Class II Permissive Change Letter

FCC ID: 2AXEK-X88

The new PCB changes are shown as following:

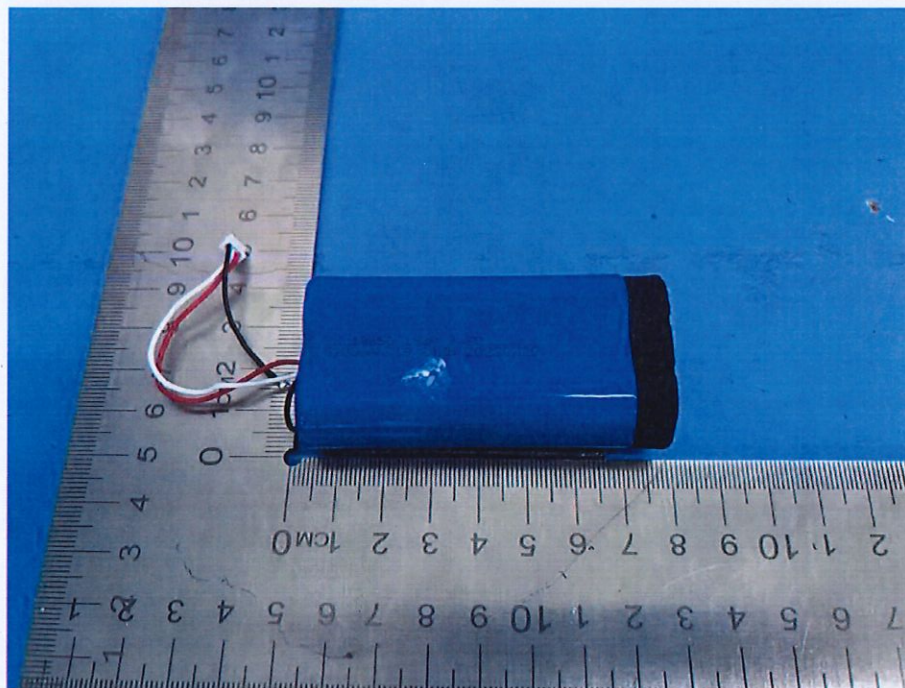
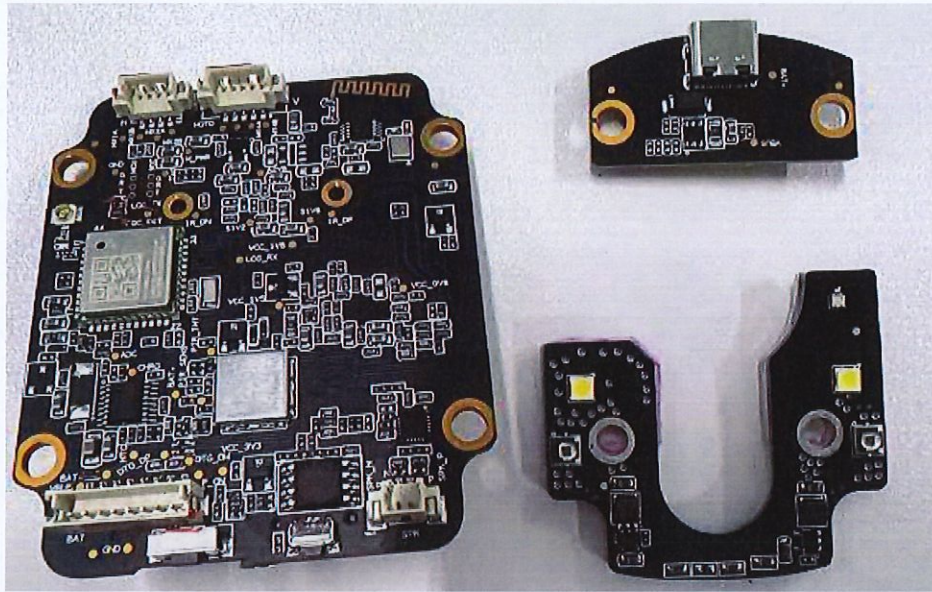
- 1, A spot was reserved Model:LN809C2641MR-G but do not install;
- 2,Optimize Image sensor Model:SC3336 layout
- 3,Add Shielding cover for PIR;
- 4,Modify speaker amp from Model:CS8138S to Model:BCT8933EGP-TR as well as RC, and Optimize layout
- 5,Change USB micro to USB TYPE-C;
6. The copper plating process is replaced by the tin plating process;
- 7.Change the battery pack from SZWATEC-21700-4500-2P to PX-INR18650-26EC 5200Ah
